#	Question	EPRI MRP Response
1	<p>The letter dated October 10, 2014, and the January 21, 2015, public meeting with the NRC staff (ADAMS Accession No. ML15021A504) included changes to the requirements for a peening process to be covered by MRP-335, Revision 1, and thus the input variables for the deterministic and probabilistic calculations. Examples include significant reductions in peening penetration depths for J-groove welds and reactor upper-head penetration nozzles. In order to assure that the NRC staff is reviewing the proper input variables, please provide a complete listing of all bounding peening input variables for the deterministic and probabilistic calculations including but not limited to, area of coverage, depth of peening, compressive stresses at depth, and associated inspections. Please note that any inputs not provided here will not be considered in the NRC staff's analysis. Additionally note that when the safety evaluation resulting from the NRC staff's evaluation of this document is used as a basis for relief from inspection requirements the input values provided to this question must be achieved by the peening process for which relief would be requested.</p>	<p>

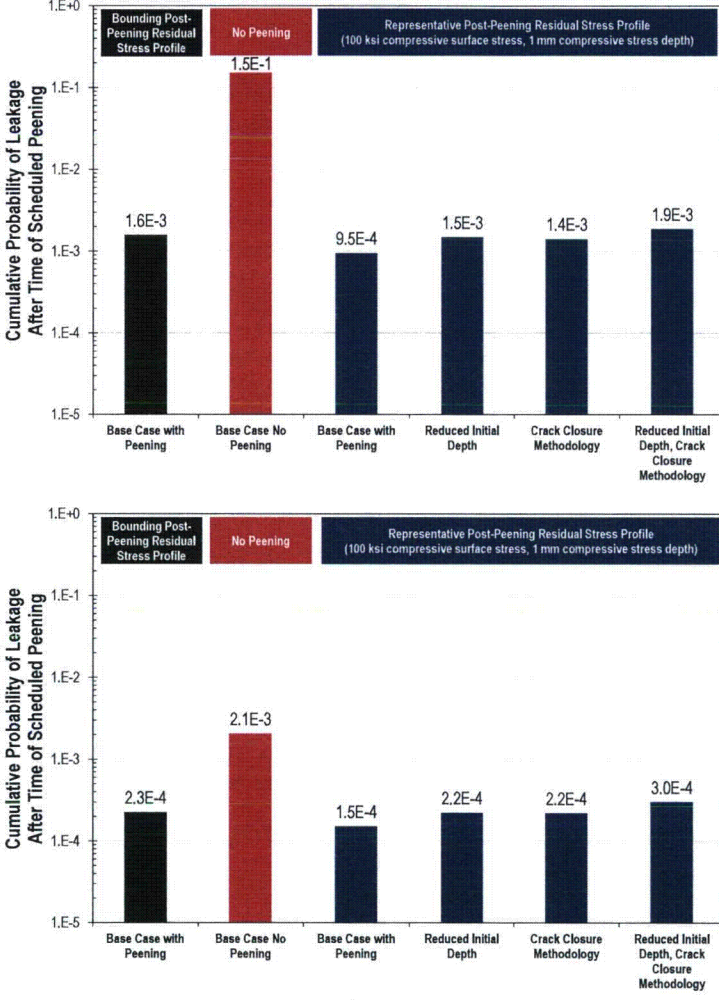
7	<p>Please provide error bars to the deterministic analysis figures showing the effects of the uncertainties discussed in Sections A.8 and B.8.</p>	<p>The relevant uncertainties for the deterministic PWSCC crack growth calculations are those for the stress, temperature, and material variability inputs. The probabilistic calculations explicitly address these and other sources of uncertainty. The temperature and material variability inputs are modeled as a simple multiplicative factor on time.</p> <p>Consistent with the discussions on the April 13, 2015, conference call between NRC and EPRI MRP, the main revised deterministic crack growth calculations in Attachment 3 reflect the minimum stress effect meeting the performance criteria (documented in Attachment 2). EPRI MRP understands that this approach will be sufficient to address this RAI question. Deterministic sensitivity cases are included in Attachment 3 to investigate the effect of a post-peening stress profile representative of stress measurements documented in MRP-267R1.</p>

Figure 5-13
Time to Through-Weld Growth vs. Initial Crack Depth for Circumferential Crack on a RVIN
($T=563^{\circ}\text{F}$ and $2c_0/a_0=8.5$)

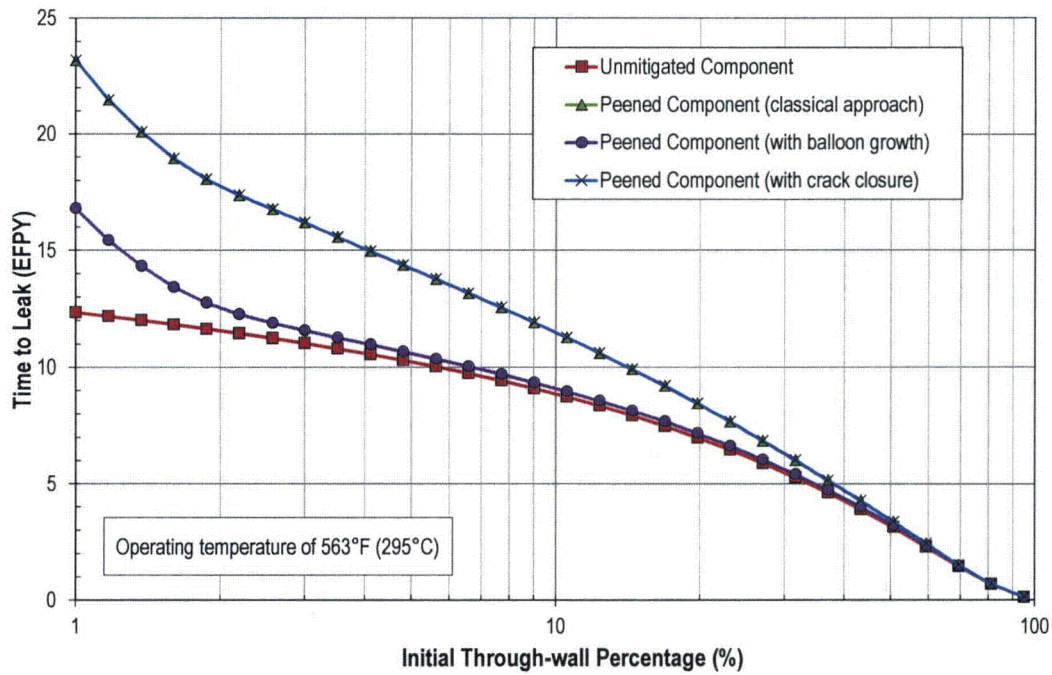
#	Question	EPRI MRP Response
10	<p>The deterministic analysis found that the crack growth rates are sensitive to the use of the crack closure model (see Figure 5-13). Shallow initial flaws subjected to partial closure constitute a limiting, but realistic, condition. Section A.9.3 mentions a sensitivity case aimed at addressing crack closure effects, which have been shown to be important in deterministic studies.</p> <p>The NRC staff notes that it is necessary to include both updated K solutions and sample shallow initial flaw sizes to truly account for crack closure. What was the initial flaw size distribution included in the Crack Closure Methodology sensitivity case (Case 13)?</p>	<p>In terms of through-wall fraction, the initial flaw size used was a log-normal distribution with a log-μ parameter of -3 and a log-σ parameter of 0.35. For the Alloy 82/182 piping dissimilar metal butt weld (DMW) example cases (i.e., 70 mm thickness), this equates to a 5th percentile of roughly 2 mm, a median of 3.5 mm, and a 95th percentile of roughly 6 mm. This distribution generally exceeds the 1 mm compressive residual stress depth used for DMW IDs. For the RPVHPN example cases (i.e., 16 mm thickness), this equates to a 5th percentile of roughly 0.4 mm, a median of roughly 0.8 mm, and a 95th percentile of roughly 1.4 mm. This distribution generally exceeds the 0.25 mm compressive residual stress depth used for nozzle IDs and straddles the 1 mm depth used for nozzle exteriors.</p> <p>Given that the initial flaw depth distributions used in the sensitivity cases employing the partial crack closure methodology generally exceeded the modeled compressive depth of residual stresses, it is informative to repeat the DMW cases with an initial flaw depth distribution shifted to lower values. For the purpose of this sensitivity investigation, it is appropriate to assume a peening stress effect representative of stress measurements documented in MRP-267R1 (as documented in Section 5.2.1 of Attachment 3) rather than the minimum stress effect meeting the performance criteria. The crack closure effect clearly has a greater potential influence for the "representative" case.</p> <p>The DMW example cases were repeated using an initial depth distribution with a 5th percentile of roughly 0.2 mm, a median of 0.35 mm, and a 95th percentile of roughly 0.6 mm. This distribution is consistently below the 1 mm compressive residual stress depth used for DMW IDs and is generally below the compressive depth even after superimposing operational stresses for the peening effect assumed here. The results are shown in the figures below:</p> <ul style="list-style-type: none"> • The reduction in initial depth results in increased leakage likelihood for DMWs (by a factor of about 1.5). This increased likelihood is due to the greater possibility of shallow flaws being present that are not reliably detectable at the pre-peening examination. Nonetheless, the leakage likelihood for peened DMWs with a relaxed in-service inspection schedule remains well below that predicted for unpeened components inspected in accordance with the applicable requirements for unmitigated DMWs. • The application of the partial crack closure methodology with the reduction in initial depth has a rather small effect on the leakage predictions. This is because flaws generally reside in one of two states at the time of peening: i) shallower than compressive stress layer resulting from peening and therefore fully closed and arrested or ii) appreciably deeper (e.g., two times or more) than the compressive stress layer and therefore largely unaffected. The fraction of flaws between these states — i.e., the fraction of flaws for which partial crack closure may be important — is small for peening. Partial crack closure has been found to be more important for deeper stress improvement methods like mechanical stress improvement.

Figure 5-32
Circumferential Crack Length vs. Time for Through-Wall Cracks Along the Weld Contour

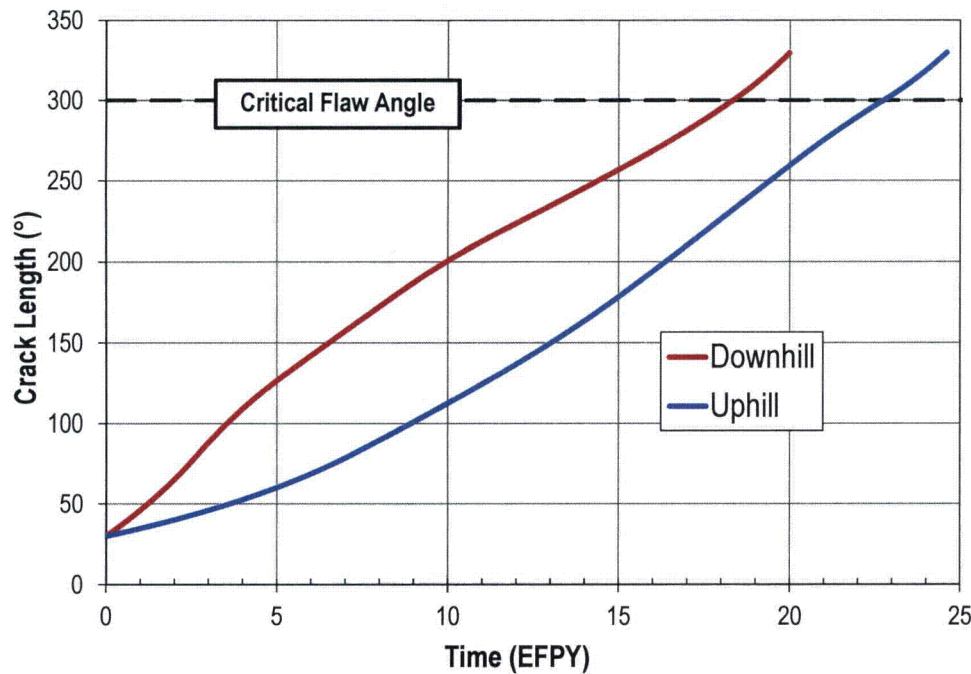
#	Question	EPRI MRP Response
14	<p>Figures 5-32 and B-31 show that the nozzle-ejection probability is very sensitive to, and increases with, the length of the in-service inspection interval. The results of the probabilistic evaluations show either a small decrease in the nozzle ejection probability with peening to an increase in the nozzle ejection probability coupled with the inspection frequency change. Given that peening the upper head can increase the nozzle ejection frequency and the sensitivity of the nozzle ejection frequency to the inspection interval, please explain how the probabilistic results support the requested increased Inspection intervals.</p>	<p>As calculated, frequencies of pressure boundary rupture often vary over multiple orders of magnitude, and the absolute acceptance criterion for the time-averaged nozzle ejection frequency (per head) may be taken as 5×10^{-5} per year. (An initiating event frequency of 5×10^{-5} per year results in a core damage frequency of no more than about 1×10^{-6} per reactor year considering the range of conditional core damage probabilities applicable to piping breaks of relevant size. The 1×10^{-6} per reactor year criterion is consistent with the change in core damage frequency criterion of U.S. NRC Regulatory Guide 1.174 for permanent changes in plant design parameters, technical specifications, etc.) On that basis, the results are only modestly sensitive to the inspection interval.</p> <p>The original probabilistic results in MRP-335R1 support the proposed inspection intervals proposed in MRP-335R1 on the basis that:</p> <ul style="list-style-type: none"> the absolute acceptance criterion for nozzle ejection frequency is satisfied, and the nozzle ejection frequency for the peened head with extended intervals is close to that for the unmitigated head examined per the N-729-1 intervals (i.e., every cycle for a hot head) (risk neutral). <p>The revised probabilistic results in Attachment 5, which reflects the revised inspection intervals and performance criteria in Attachment 2, satisfy these same acceptance criteria. As shown in Figure 5-36 (hot head) of Attachment 3 and Figure B-3 (cold head) of Attachment 5, the risk neutral condition is clearly satisfied.</p>
